Technical Service Bulletin

SUBJECT:		No: TSB-22-51-002	
REAR (AIR) SPOILER CRACK		DATE: August 2022	
		MODEL: See Below	
CIRCULATE TO:	<input type="checkbox"/> GENERAL MANAGER	<input checked="" type="checkbox"/> PARTS MANAGER	<input checked="" type="checkbox"/> TECHNICIAN
<input checked="" type="checkbox"/> SERVICE ADVISOR	<input checked="" type="checkbox"/> SERVICE MANAGER	<input checked="" type="checkbox"/> WARRANTY PROCESSOR	<input type="checkbox"/> SALES MANAGER

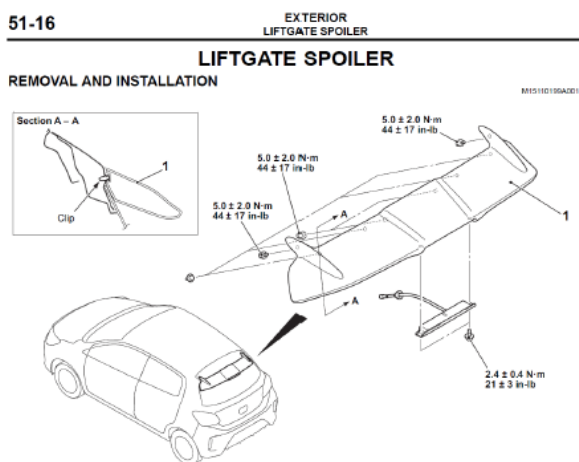
A customer may find a crack on the Rear Spoiler, also known as Air Spoiler. Multiple factors such as heavy pad compression on the spoiler bolt retainer during shipping and vast temperature fluctuations causing shrinkage and expansion may be the cause.

This TSB instructs the dealers to replace the Air Spoiler, RR on a customer complaint basis.

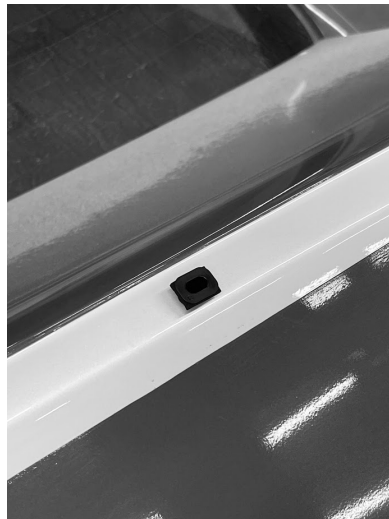
1. Open the trunk lid and remove the bolts for the Air Spoiler.

2. Insert tool between the Air Spoiler and trunk lid, then gently pry to remove.
